VTM COMPLIANCE EXHIBITS
 TITLE PAGE
 MIRAMONTE
 SOLEDAD, CALIFORNIA
 APRIL, 2021

VTM COMPLIANCE EXHIBITS
KEY MAP
MIRAMONTE
SOLEDAD, CALIFORNIA
APRIL, 2021

VTM COMPLIANCE EXHIBITS
STREET SECTIONS
MIRAMONTE
SOLEDAD, CALIFORNIA
APRIL, 2021

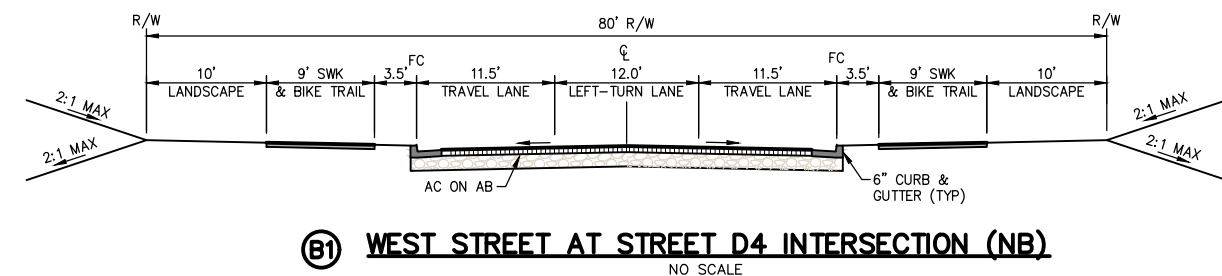
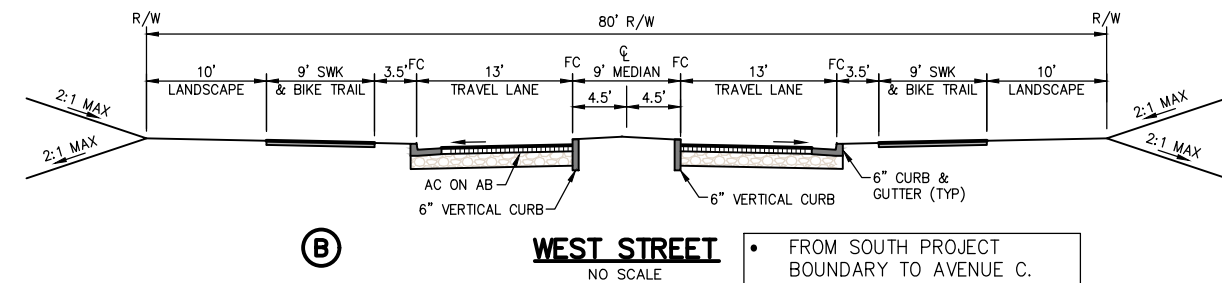
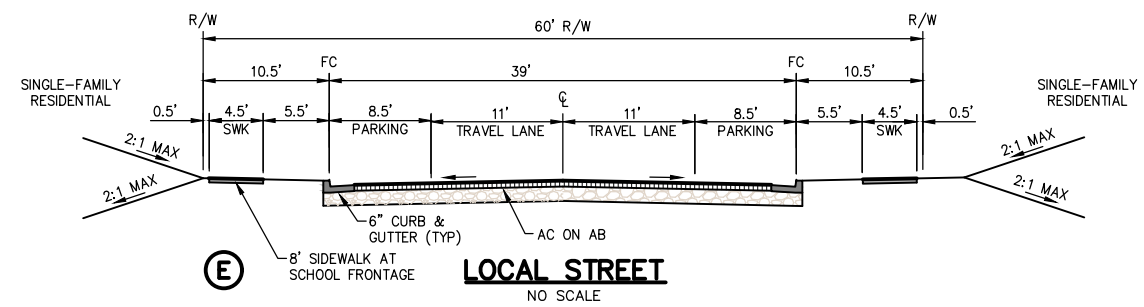
1. SAN VICENTE ROAD: SECTION A -
 - a. SHOULDER ONLY ON THE WEST SIDE TO ACCOMMODATE FARM OPERATIONS
 - b. SIDEWALK WIDENED TO 10' ON THE EAST (PROJECT) SIDE
 - c. ADDITIONAL 20' WIDE COMMON LANDSCAPE ON WEST SIDE
2. SAN VICENTE ROAD: SECTION A1 - SECTION FOR THE EXTENSION
3. WEST STREET:
 - a. PRIMARY SECTION B - NO CHANGE
 - b. NEW SECTION B1 - LEFT-TURN LANE ADDED AT STREET D4 INTERSECTION AS RECOMMENDED BY THE CITY'S TRAFFIC CONSULTANT

VTM COMPLIANCE EXHIBITS
 STREET SECTIONS
 MIRAMONTE
 SOLEDAD, CALIFORNIA
 APRIL, 2021

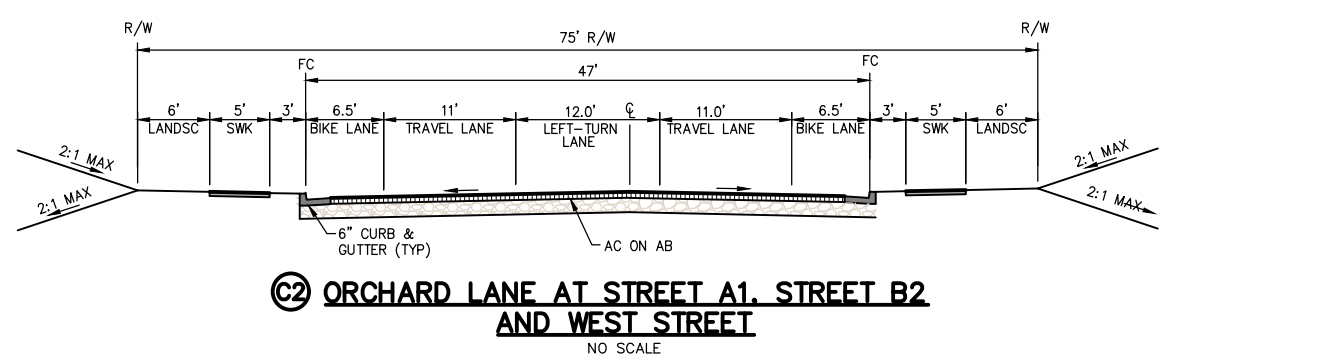
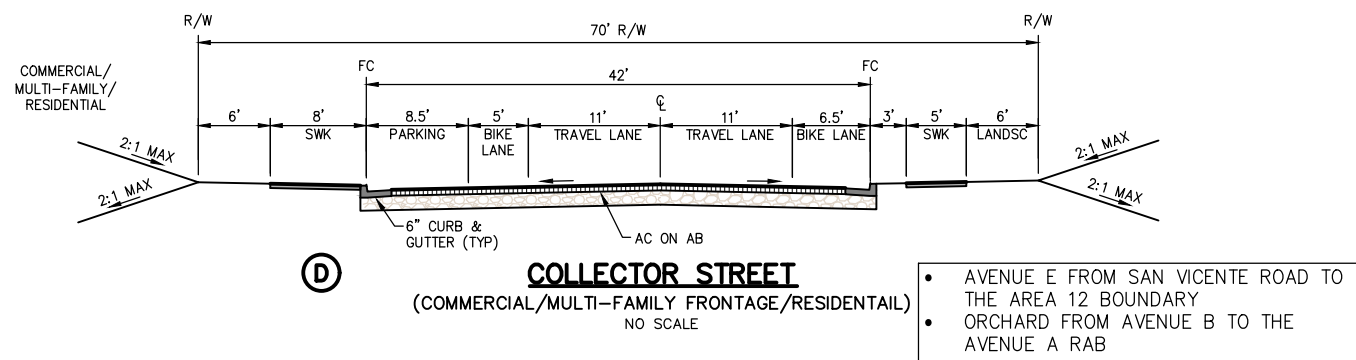
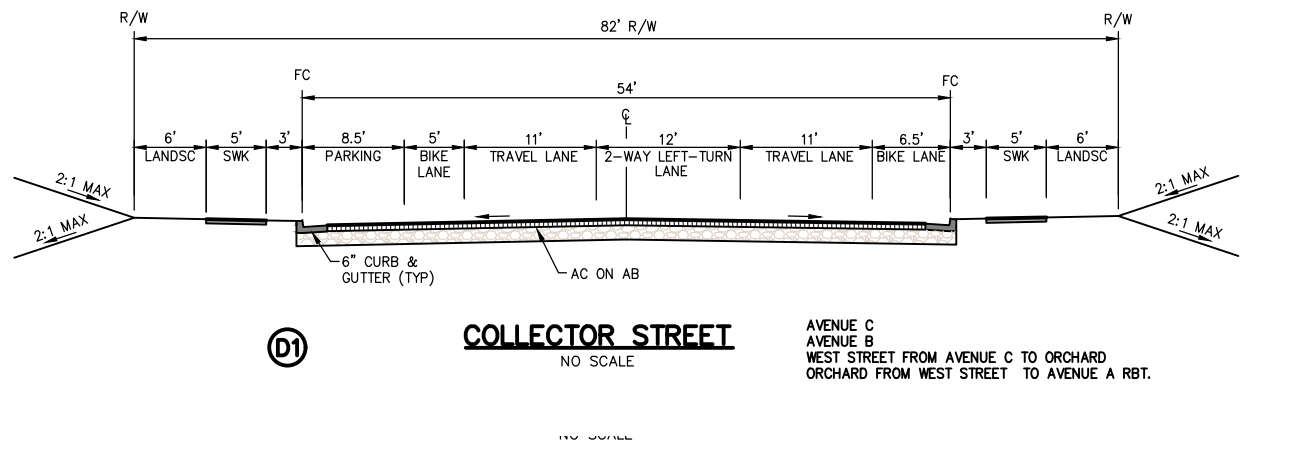
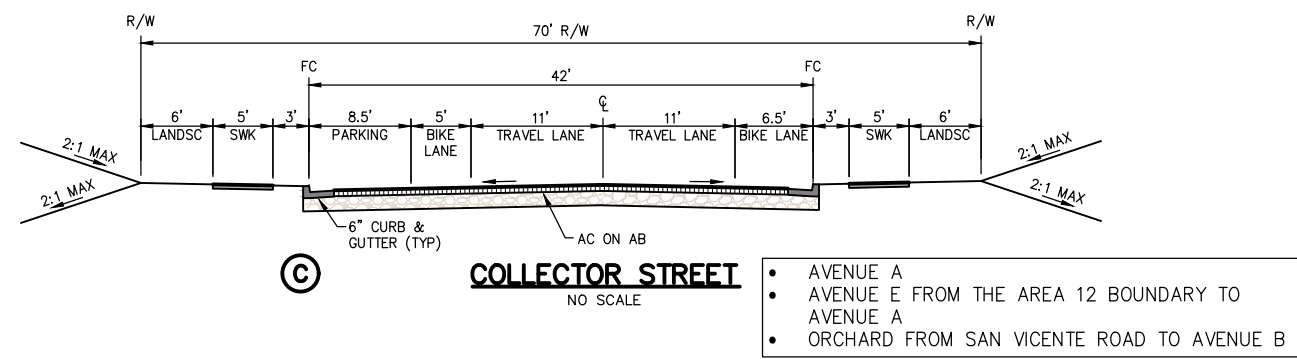
1. LOCAL STREETS:
 - a. PRIMARY SECTION E - NO CHANGE FROM VTM
 - b. NEW SECTION E1 - WIDENED SIDEWALK AT SCHOOL FRONTAGES PER SPECIFIC PLAN REQUIREMENTS
2. UNPAVED TRAIL SECTION S - NEW SECTION PER SPECIFIC PLAN
3. PAVED TRAIL SECTION T - LANDSCAPE AREA ADDED TO EACH SIDE

<p>VTM COMPLIANCE EXHIBITS STREET SECTIONS MIRAMONTE SOLEDAD, CALIFORNIA APRIL, 2021</p>	 <p>RUGGERI-JENSEN-AZAR ENGINEERS ■ PLANNERS ■ SURVEYORS 8055 CAMINO ARROYO GILROY, CA 95020 PHONE: (408) 848-0300 FAX: (408) 848-0302</p>
--	--

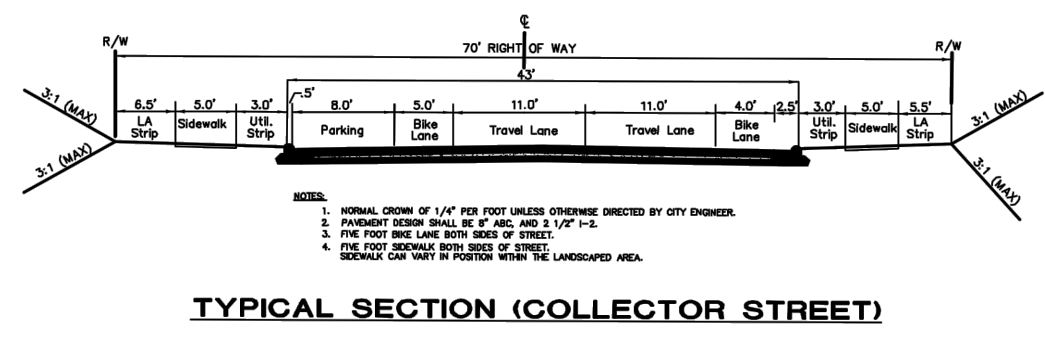
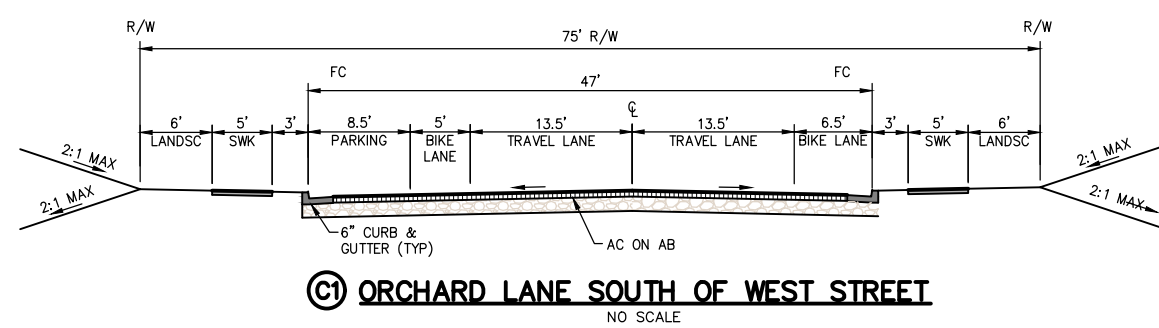
- COLLECTOR STREETS:
 - PRIMARY SECTION C - MINOR CHANGES FOR SYMMETRY
 - NEW SECTION D1:
 - ADDED THE TWO-WAY LEFT-TURN LANE AS RECOMMENDED BY THE CITY'S TRAFFIC CONSULTANT
 - WIDENED SIDEWALK AT COMMERCIAL AND MULTI-FAMILY FRONTAGES PER SPECIFIC PLAN REQUIREMENTS
 - NEW SECTION D - WIDENED SIDEWALK AT COMMERCIAL AND MULTI-FAMILY FRONTAGES PER SPECIFIC PLAN REQUIREMENTS
- ORCHARD LANE: SECTION C1 & C2 - ROW WIDENED 5':
 - NEW SECTION C1 PARKING ONE SIDE OTHER THAT AT INTERSECTIONS
 - NEW SECTION C2 PARKING LANE REMOVED TO ACCOMMODATE A LEFT-TURN LANE AT INTERSECTIONS AS RECOMMENDED BY THE CITY'S TRAFFIC CONSULTANT

**VTM COMPLIANCE EXHIBITS
SAN VICENTE RE-ALIGNMENT**

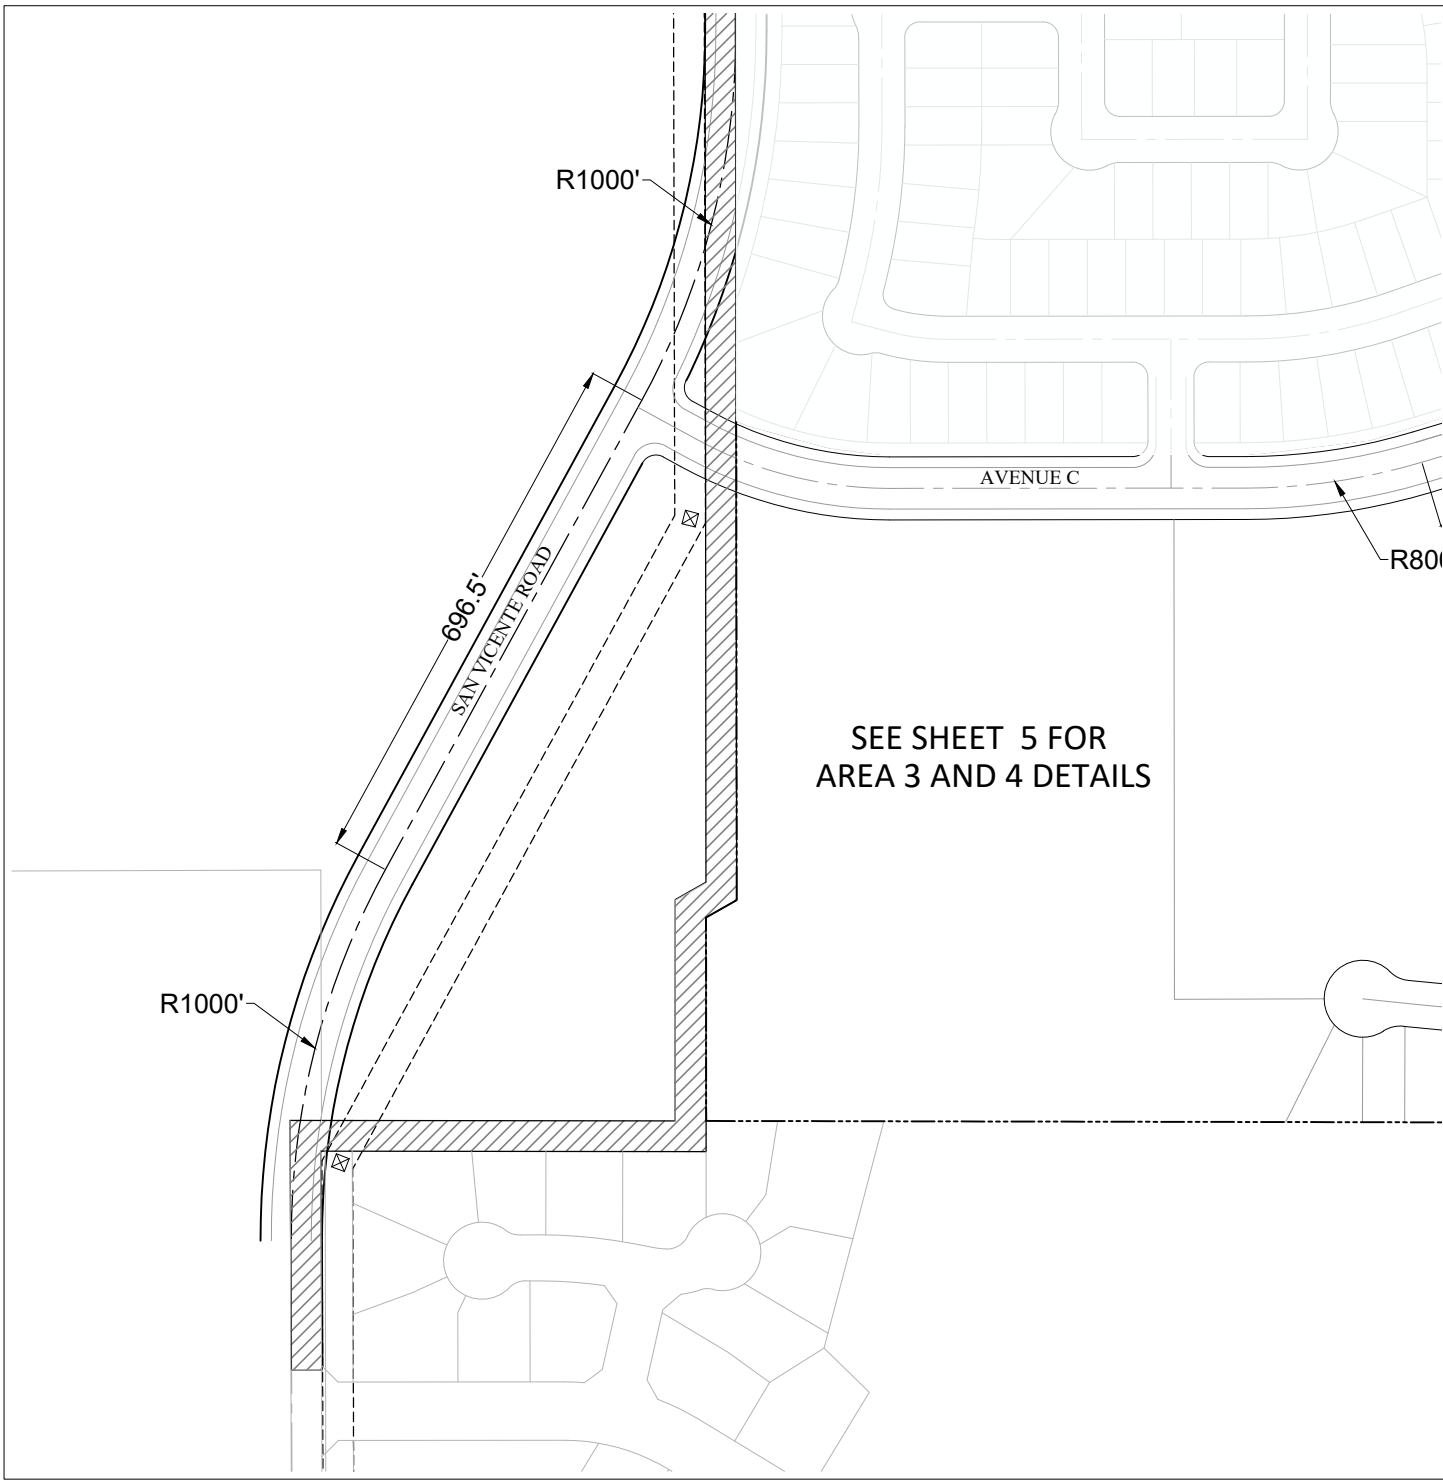
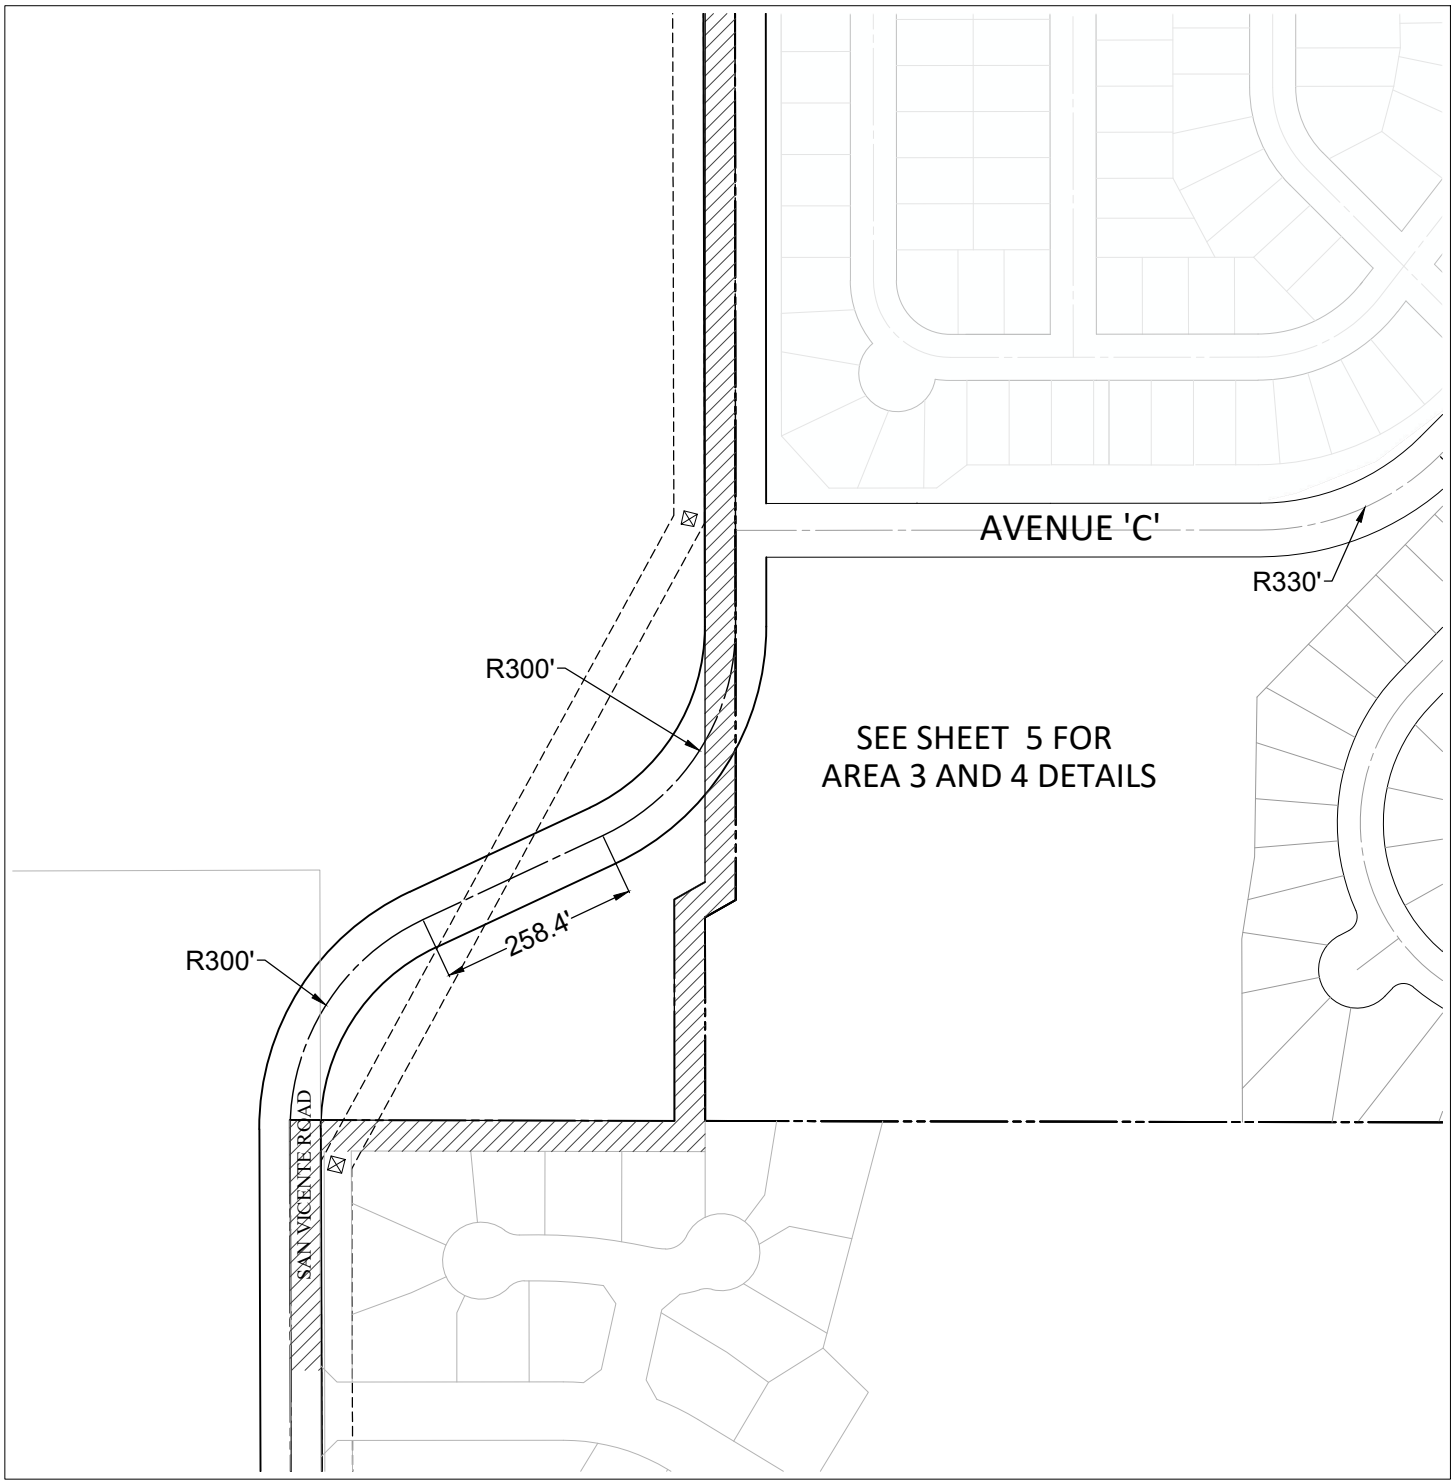
CURVE RADII INCREASED TO PROVIDED THE APPROPRIATE DESIGN SPEED:

<u>PROPOSED LAND PLAN</u>	<u>2018 VESTING TENTATIVE MAP</u>
CURVE RADII:	1000	300
MAXIMUM COMFORTABLE SPEED:	45 MPH	28 MPH

PROPOSED DESIGN COORDINATED WITH THE CITY'S TRAFFIC CONSULTANT
